Permit Number: 080859

has permission to Portion of Building "A" - add window & wall for ventilation for Casco Bay High School

AT 174 ALLEN AVE Portland, ME 04101 343 C013001

From: Douglas Sherwood
To: Gregory Cass
Date: 7/24/2008 2:33:43 PM
Subject: Re: Paths - Casco Bay High School Year 4 and last classroom

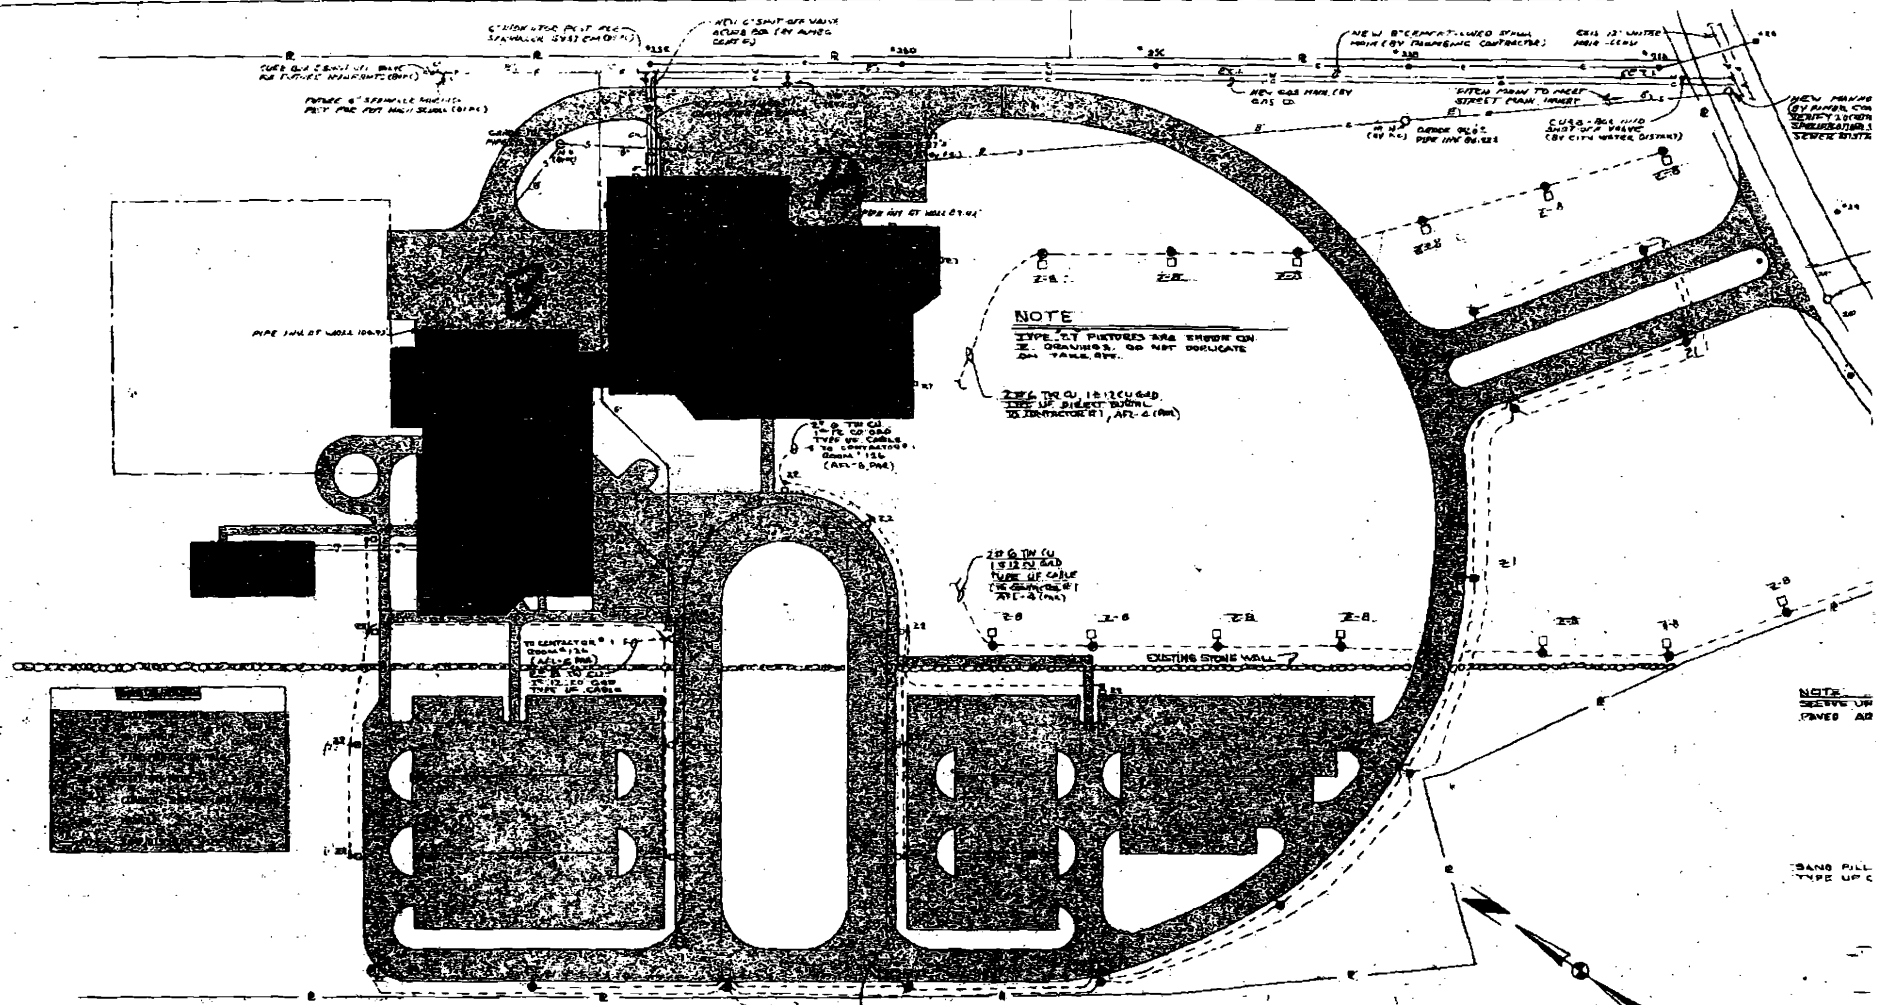
The code review shows that exit access corridors require a 1 hr. fire rating.

So the walls and doors to new room # 13 need to be up graded. The walls need 5/8" type x sheet rock not 1/2". and the doors need to be 1 hr. not 20 min.

See NFPA 101 chapter 7.1.3.1

I called Tom Hamilton and we talked about corridor width but I failed to mention that this expansion into the corridor now creates this room as the corridor. Please provide details for fire resistance for both the walls and the doors.

We will install framing, wall and door assemblies for the proposed new CBHS room #13 in the third floor corridor of Building A at PATHS that meet the one hour fire rating requirement of NFPA 101, Chapter 7.1.3.1.
